**CITY OF MAPLE GROVE
PLANNING COMMISSION AGENDA
MARCH 8, 2021
7:00 P.M.**

**Boston Scientific Building 3 West
Planned Unit Development - Development Stage Plan**

SUBJECT: Boston Scientific Building 3 West PUD Development Stage Plan – CED Review

**Reserve Arbor Lakes Building 4
Planned Unit Development - Development Stage Plan and Final Plat**

Sheet Title
**LANDSCAPE
PLAN**

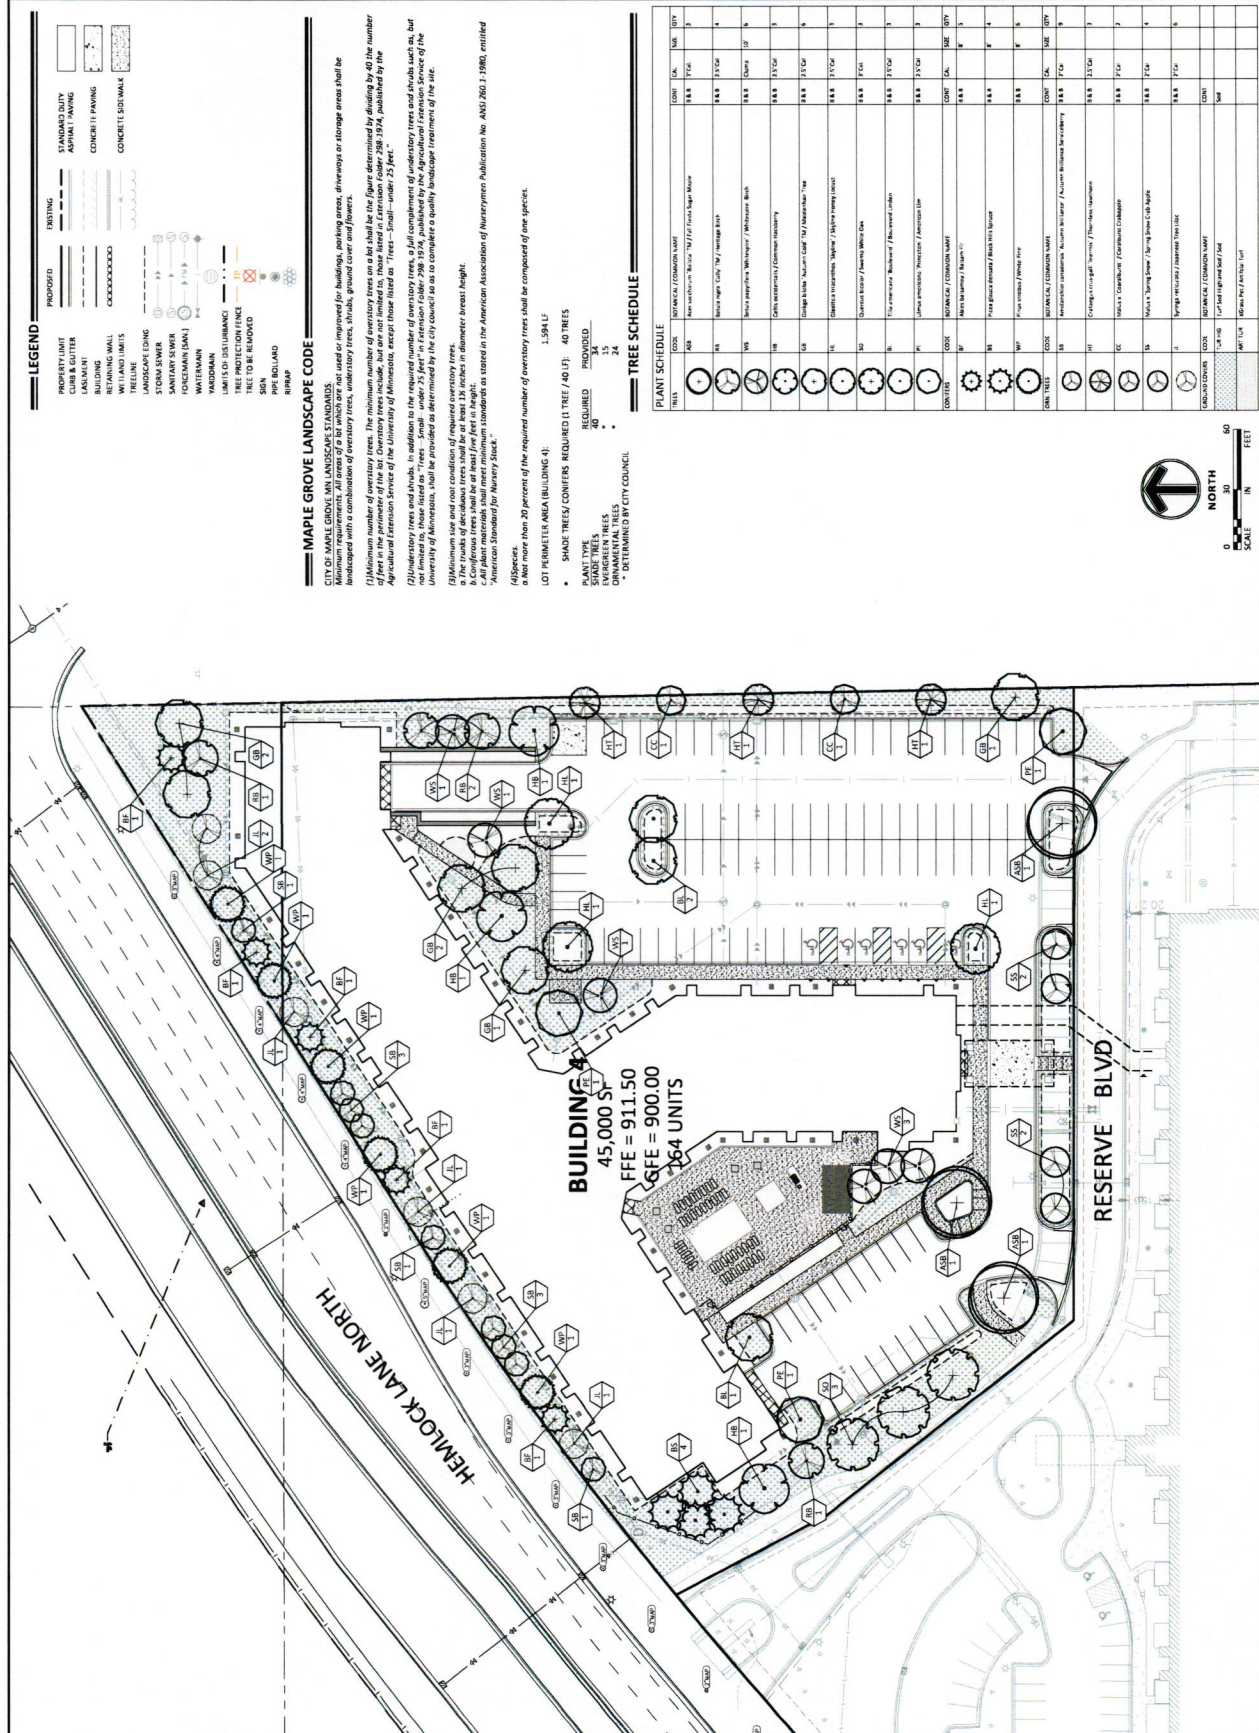
1. The elevations shall be updated to reflect the material pattern shown in the rendering.
2. Regarding the proposed landscape plan, staff has the following comments:
 - a. The maximum number of trees of any one genus is 10 (20% of 49). Please reduce the number of birch trees to no more than 10.
 - b. Please label the various tree species on the landscape plan.
